# Origination Form Proposed Revisions to a Standard Plans Index

Originator:	Turley, Joshua	Index Number:	455-114
Date:	8/21/2024	Sheet Number(s):	2
E-mail:	Joshua.Turley@dot.state.fl.us	Index Title:	14" SQUARE CFRP & SS PRESTRESSED CONCRETE PILE

STRESSED	INDEX	SHEET
	455-114	2 of 2

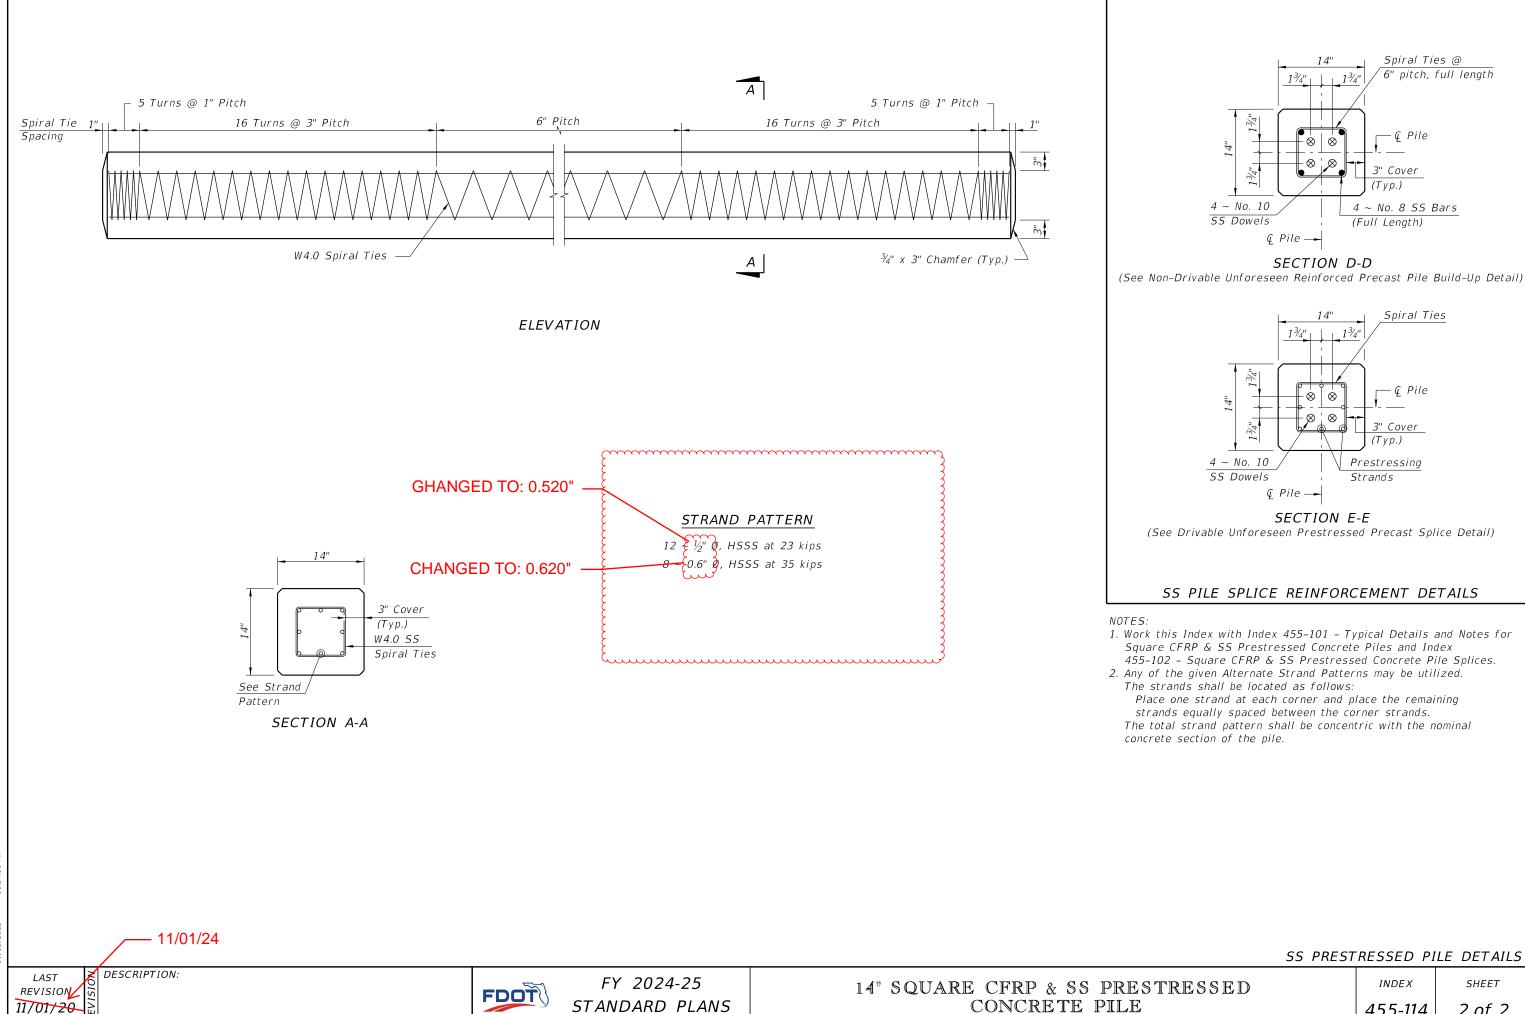
Sheet 2: Adjusted Strand Pattern diameter decimal places

This is a more accurate representation of the nominal diameter driven by the fact that the strands are fabricated in millimeters not inches.
